# Broad Band Noise Test Specification for Clause 202

Feb 03, 2026

Ahmad Chini, Broadcom

**Figure 201-36—Broadband stationary noise rejection test setup, -T1**

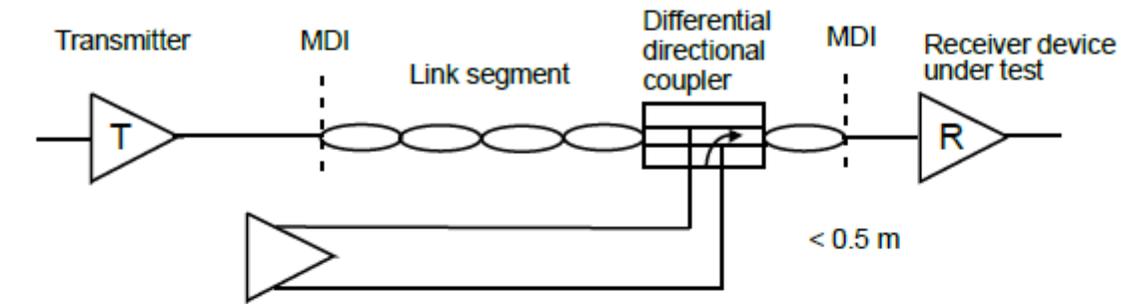
This **informative** specification is provided to verify for the receiver’s tolerance to broadband stationary noise from a variety of sources. The test is performed with a noise source consisting of a signal generator with Gaussian distribution, bandwidths, and magnitudes shown in Table 202–??. **The minimum noise frequency is 10MHz.** The receive DUT is connected to the noise source through a directional coupler, as shown in Figure 202–??. with a link segment as defined in 202.? for -T1 and shown in Figure 202–??. with a link segment as defined in 202.?? for -V1. The BER is expected to be less than  $10^{-12}$ , and to satisfy this specification, the frame loss ratio is less than  $10^{-9}$  for 125-octet packets measured at the MAC/PLS service interface.

**Editorial Note:**  
Set the figure and table numbers as fits into 202 clauses.
